# PLANNING BOARD

## NOTICE OF PRELIMINARY DETERMINATION PLANNED UNIT DEVELOPMENT PROPOSAL

Case Number:	368
Location of Premises:	Volpe Exchange Parcel – 55 Broadway (33 Broadway, 2 Potter Street, 20 Potter Street, 156 Linskey Way, 220 Binney Street, 60 Sixth Street, 182 Binney Street)
Zoning:	Business A (BA); Residence C-2B (C-2B); Office 2 (O-2); PUD-KS; PUD-7
Applicant:	Massachusetts Institute of Technology (MIT) c/o MITIMCo, One Broadway, Suite 09-200, Cambridge, MA 02142
Owners:	United States of America 10 Causeway Street, Boston, MA 02030
Application Date:	February 10, 2021
Date of Public Hearing:	April 6, 2021
Date of Determination:	April 6, 2021
Summary of Proposal:	Redevelop the Volpe Exchange Parcel into a mixed-use center including residential, retail, office and laboratory buildings, as well a Community Center pursuant to PUD-7 district requirements.
Determination:	<b>APPROVED, with conditions and requests for modification.</b>

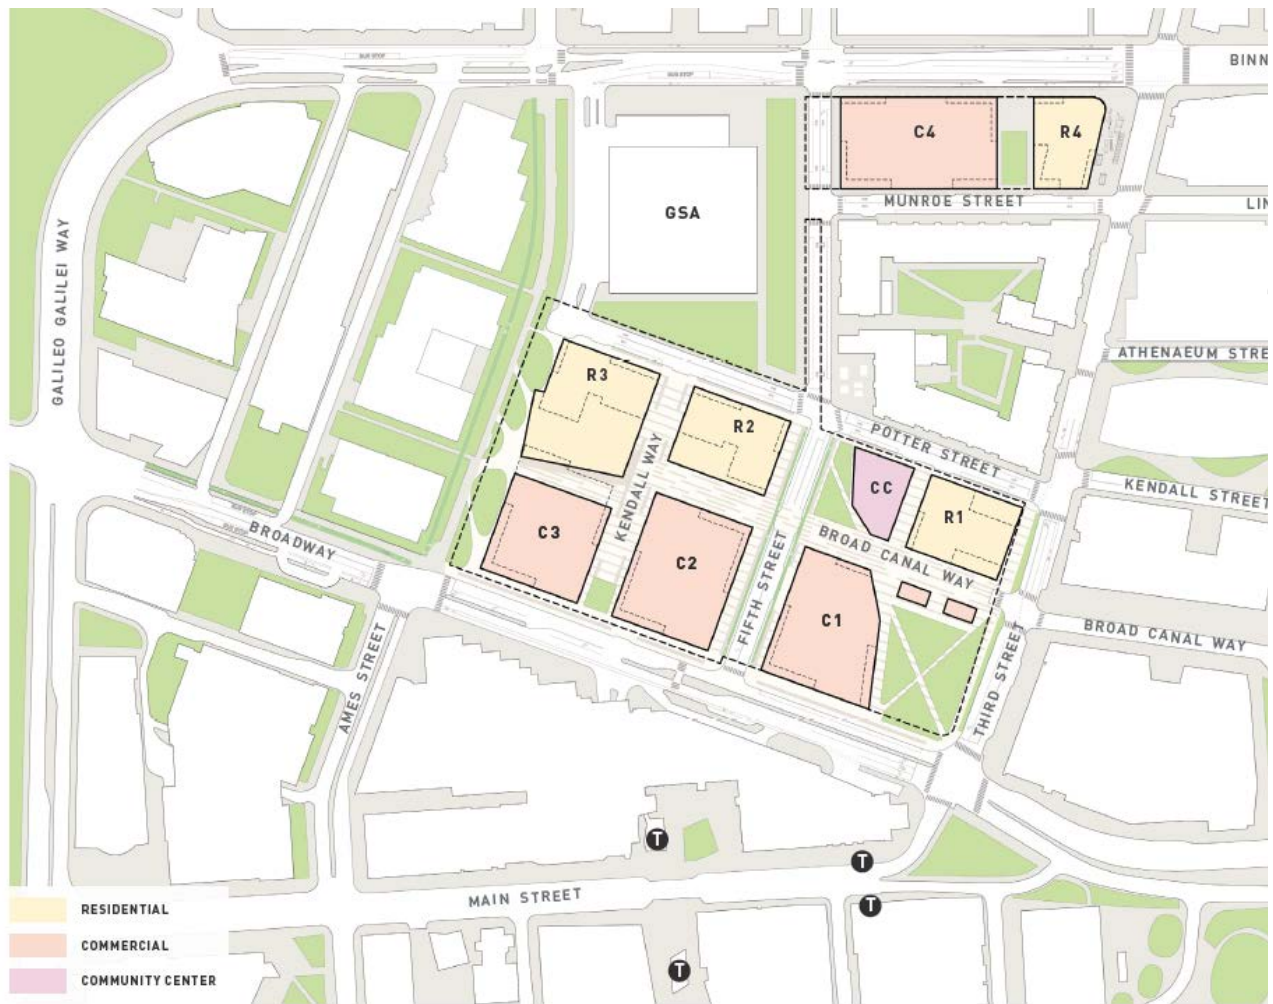
The development parcel consists of four (4) predominantly residential buildings (R1, R2, R3 & R4), four (4) predominantly commercial/lab buildings (C1, C2, C3 and C4), and a Community Center (CC) standalone building. The development also contains two (2) standalone retail pavilions along Broad Canal Way bordering Third Street Park, and an entertainment venue as part of R3. Ground-story retail, restaurant and consumer service uses are dispersed across the separate buildings, with concentrations located along Broadway, Broad Canal Way, and Third Street Park.

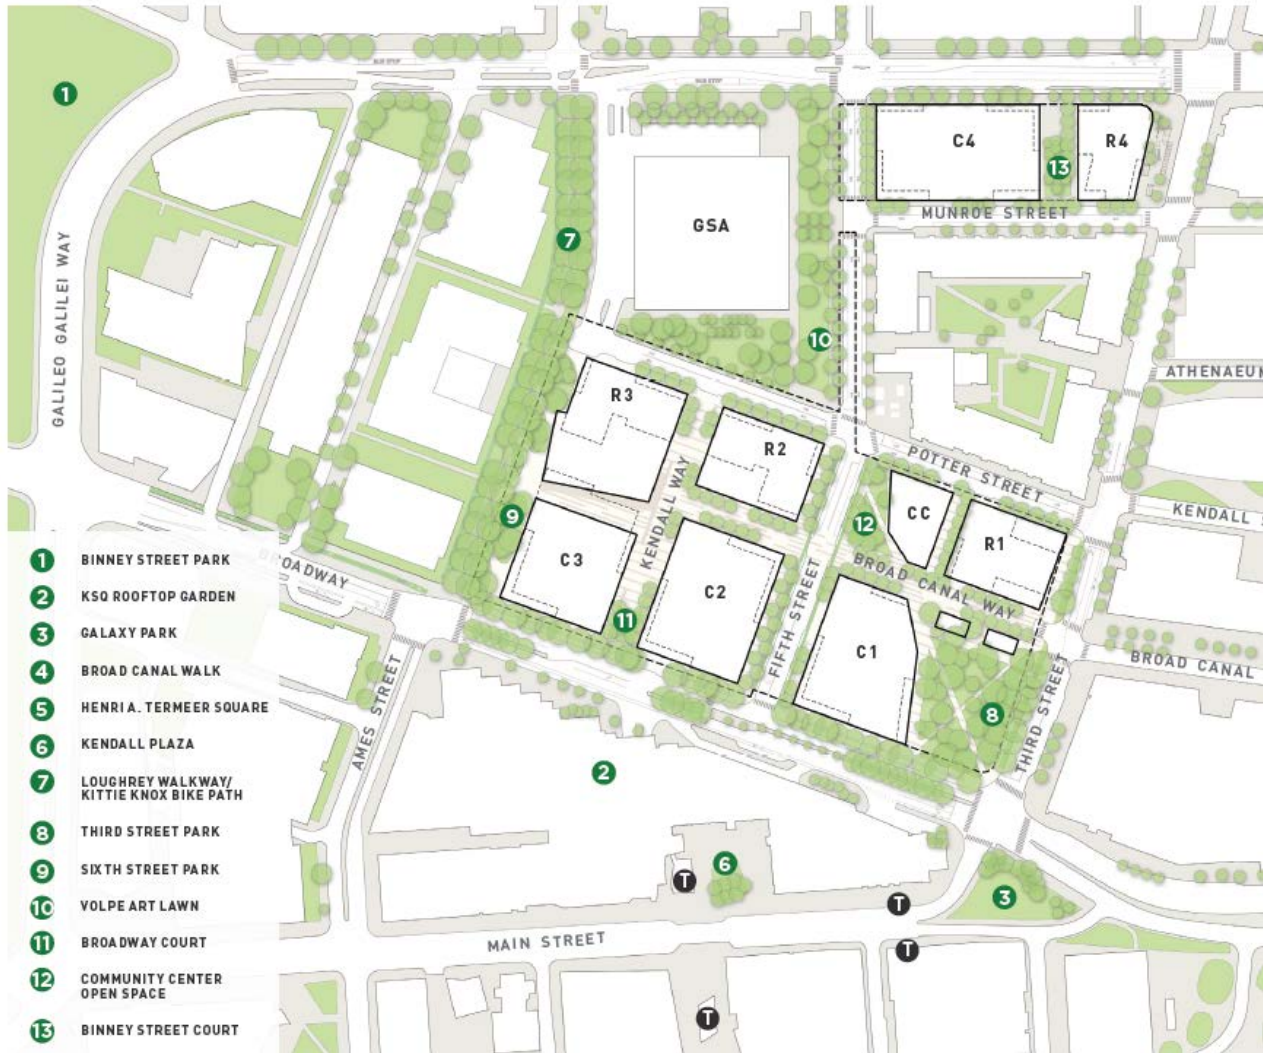
The Development Plan includes new street connections to the existing grid and throughout the site. Fifth Street is proposed to be a private way connecting Binney Street to Broadway. Potter Street is proposed to be extended as an east-west private way connecting Third Street to the south edge of the new GSA building. Broad Canal Way is proposed to be extended from Third Street westward to the Loughrey Walkway and Kittie Knox Bike Path, but is proposed to be a private way. A new north-south private way called Kendall Way will extend from Potter Street southward toward Broadway.
